V2500-D5 SERIES PROPULSION SYSTEMS SERVICE BULLETIN

This document transmits Revision 1 to Service Bulletin EV2500-79-0062

V2500-ENG-79-0062

AIR - BEARING COMPARTMENT COOLING AND SEALING TUBES - INTRODUCTION OF A REVISED
BIFURCATION TO NO. 4 BEARING SCAVENGE VALVE AIR TUBE ASSEMBLY

General view
Fig 1

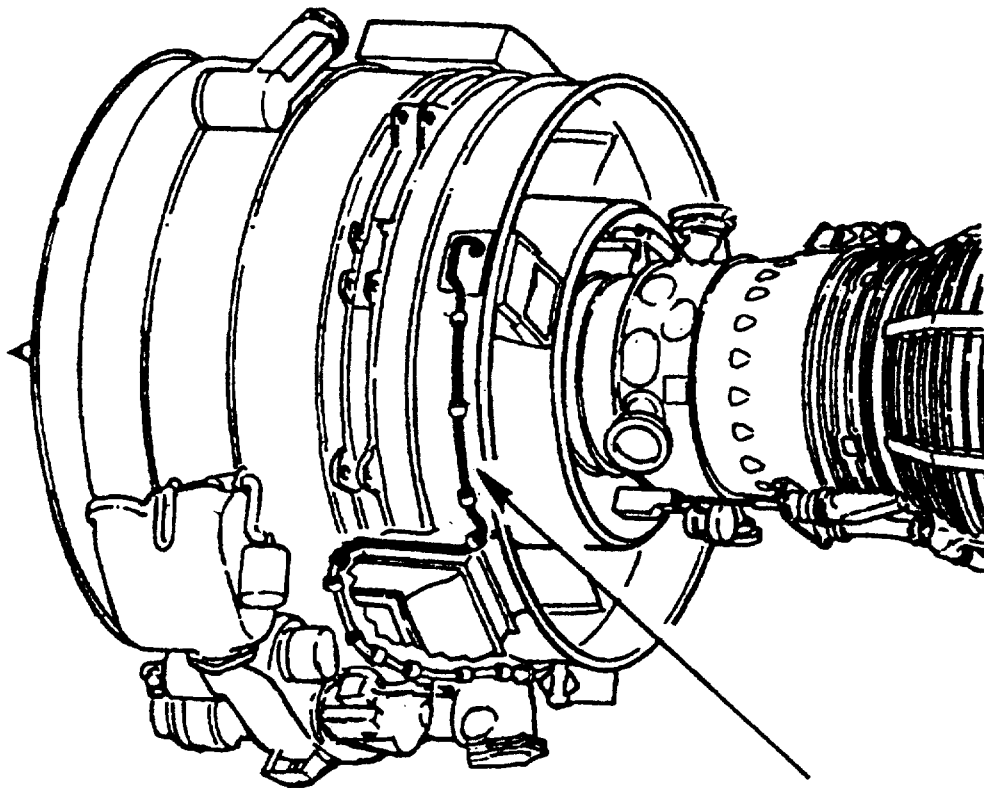
A new air tube assembly from the LH bifurcation box to the No.4 bearing scavenge valve. The tube features a 90 degree elbow at the bifurcation box end to provide additional clearance with the thrust reverser actuation fitting.

REMOVE 6A5111 AND
INSTALL 6A5328
